MCPB No. 09-15

Site Plan No. 820070220

Project Name: Clarksburg Town Center

RESOLUTION¹

PLAN "B"

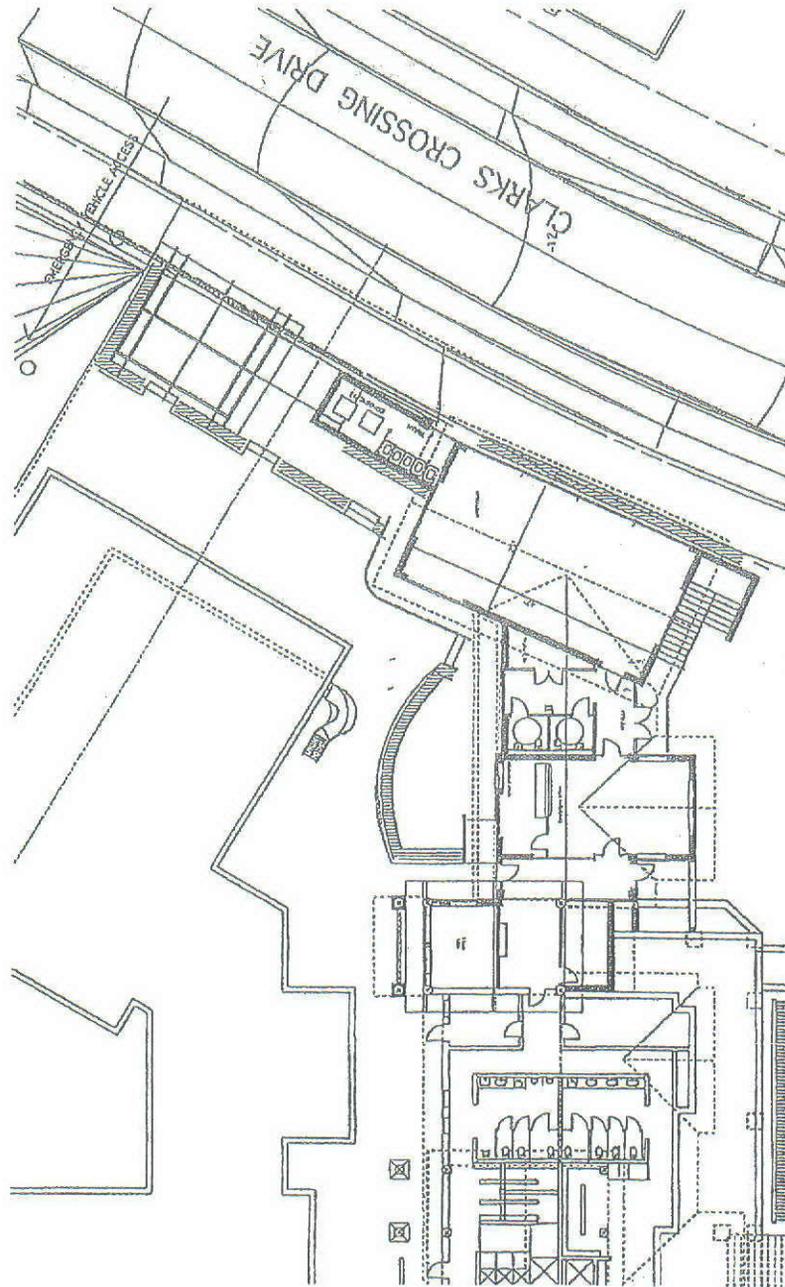
- d. The Applicant must provide the smaller sport court, referenced as "Plan B" in the November 20, 2008 exhibit provided by the Applicant
